AMENDED PETITION FOR ZONING VARIANCE Case No. 86-309-A TO THE ZONING COMMISSIONER OF BALTIMORE COUNTY:

AMENDED PETITION FOR SPECIAL EXCEPTION Case No. 86-309-A TO THE ZONING COMMISSIONER OF BALTIMORE COUNTY:

PROPOSED EDUCATION
BUILDING
ASHLAND PRESBYTERIAN
CHURCH
116 ASHLAND ROAD
ELECT. DIST. 8 BALTO. CO., MD.
SCALE 1"=20' OCT. 14, 1985
REV 12-14-85

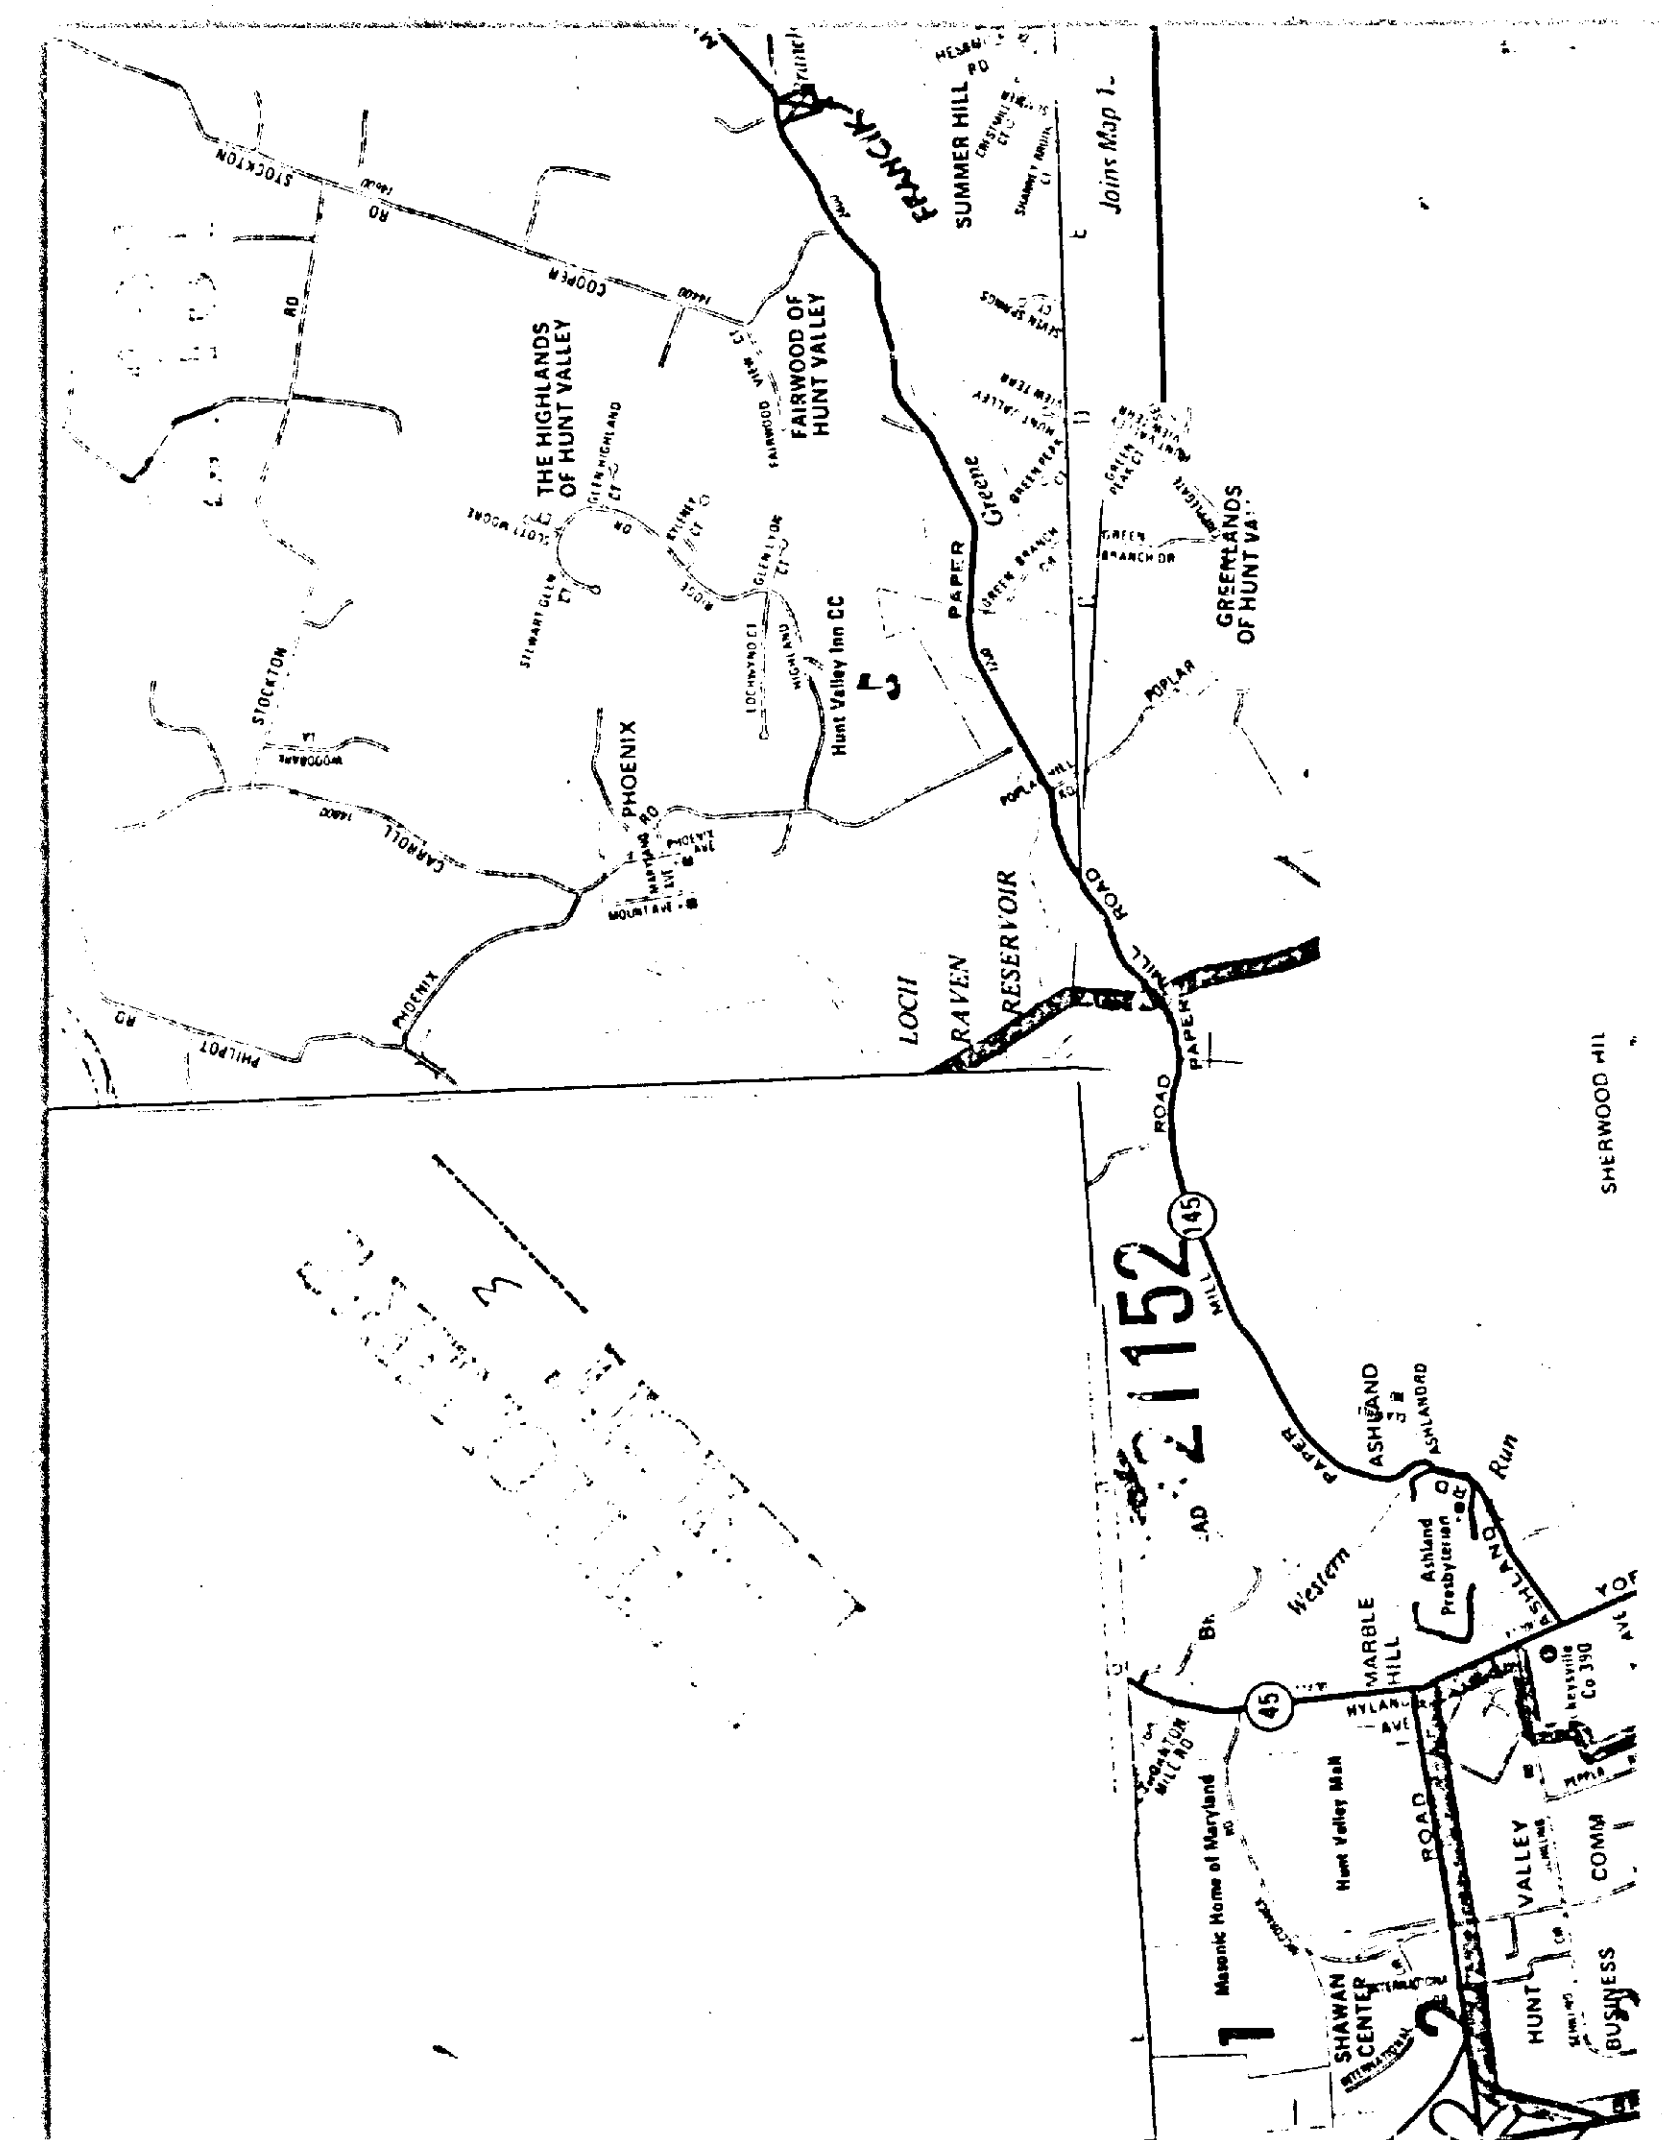
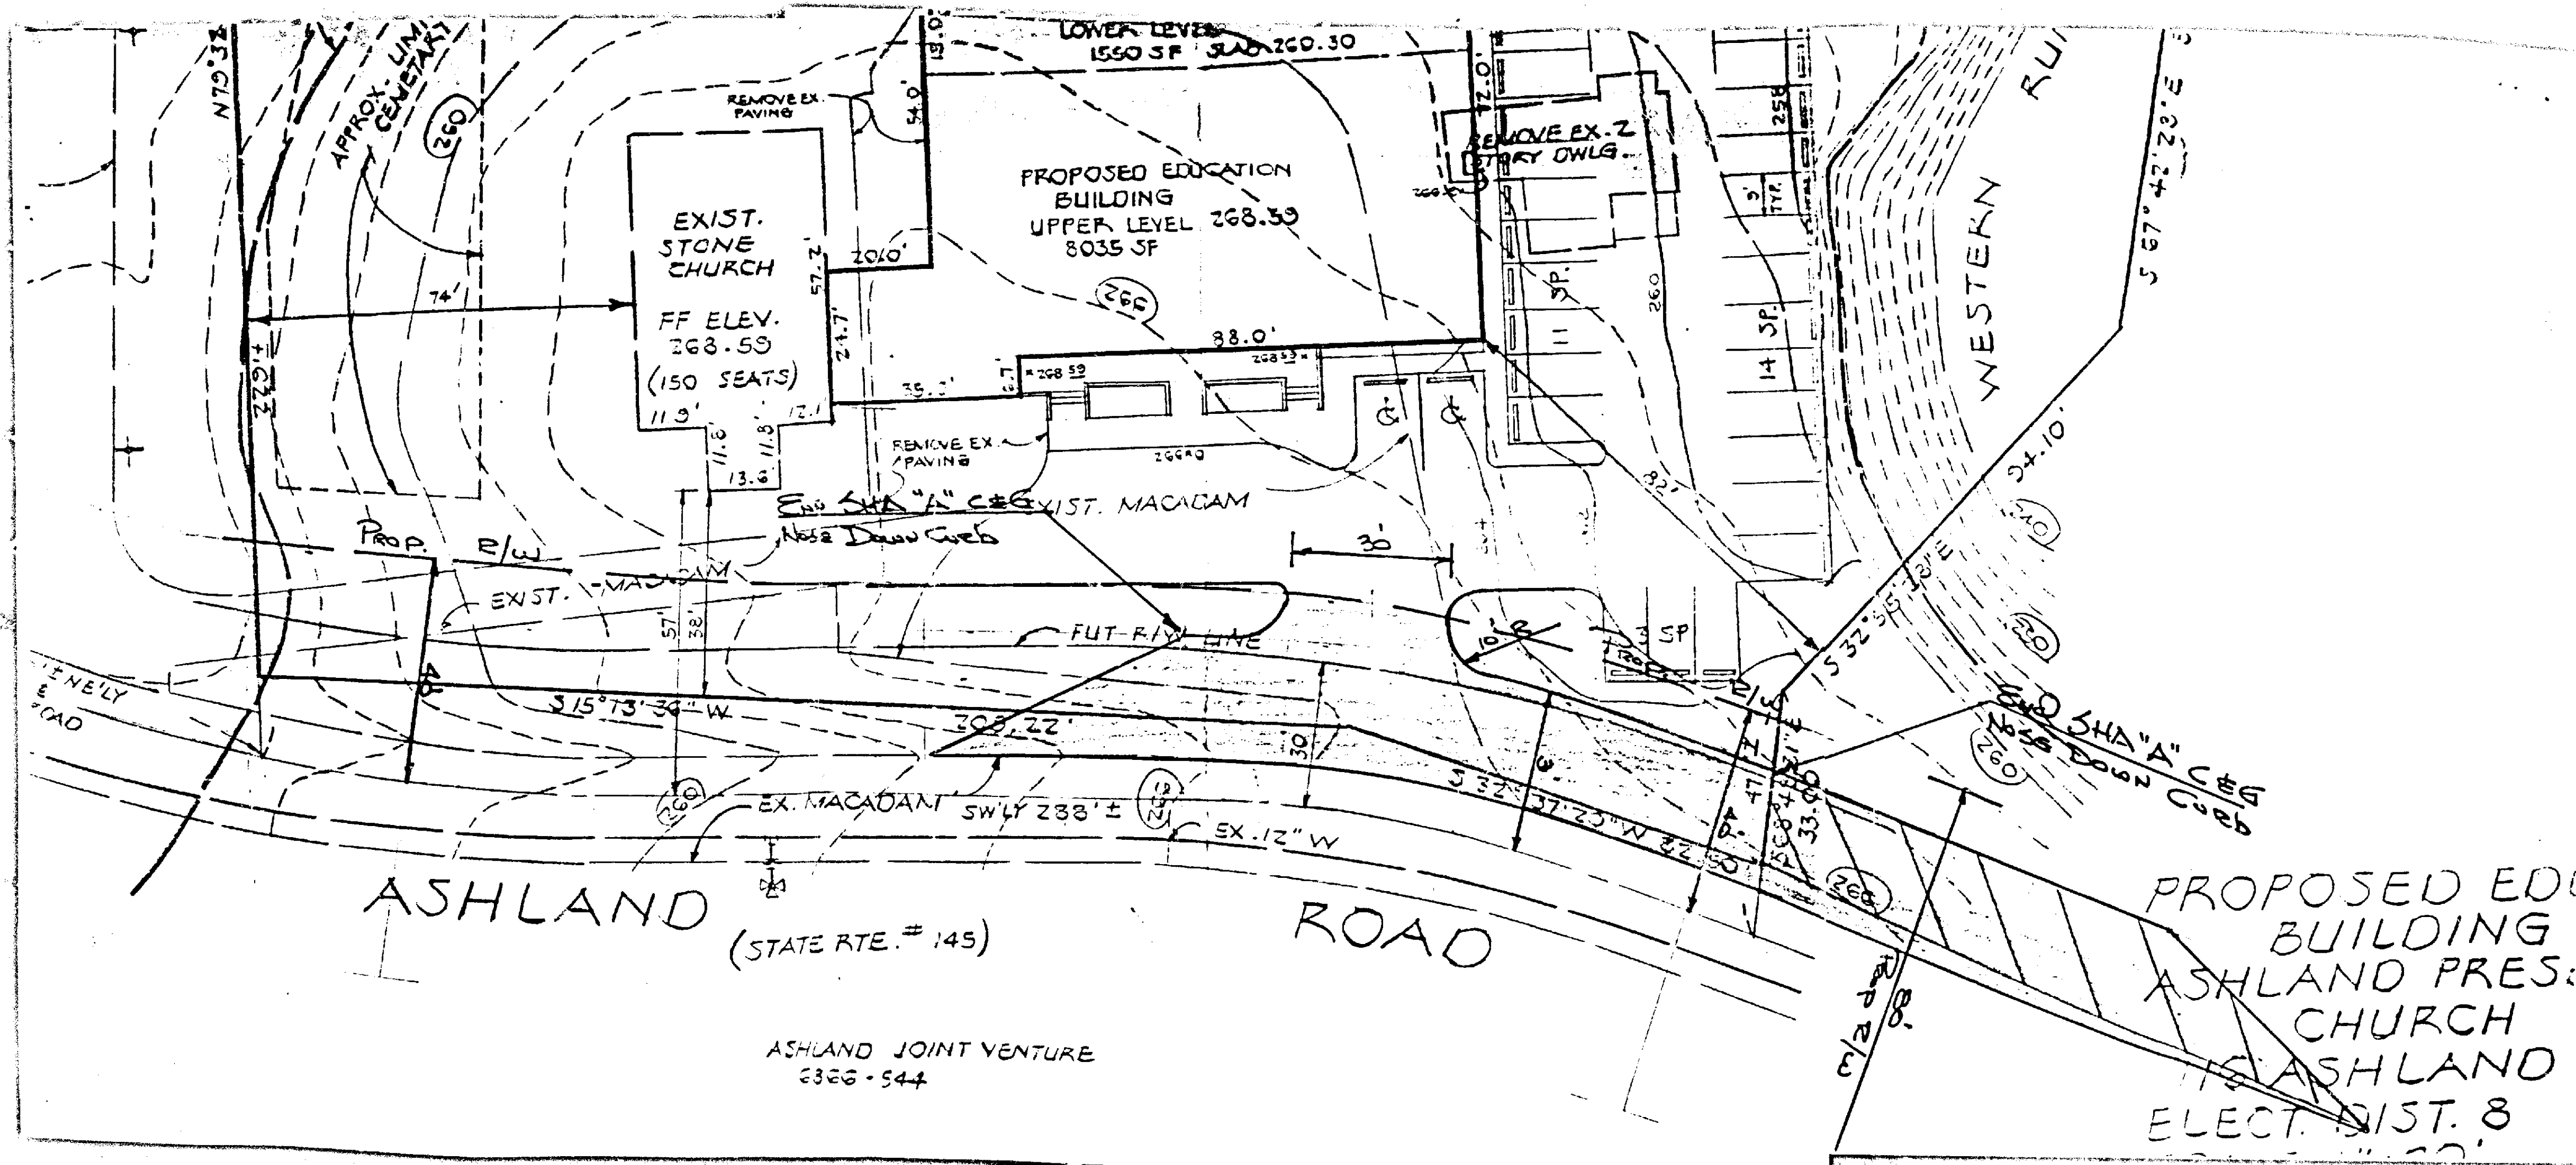
On review of the revised submittal of 12/14/85, and field inspection, the state Highway Administration will require the site plan to be revised.

The revised site plan must show the following.

1. Show a fully channelized 30' entrance with 10' radii, 80' south of the north property line.
2. Provide a channelized deceleration/acceleration lane 31' from the centerline of Ashland Road (Route 145) for a total distance of 115' with paving and tapers to meet the existing edge of roadway.

3. Construct a barrier curb (rear curb) on or in back of the proposed 80' R/W (40' 1/2 section).
4. Show a proposed 80' R/W (40' 1/2 section) from the existing centerline of Ashland Road (Route 145).

If direct access to Ashland Road from the parking lot is desired, the S.H.A. will require the revised plan to show a fully channelized entrance. (see Item 1 thru 4).

It is requested the site plan be revised, prior to a Zoning date being set for the above site.
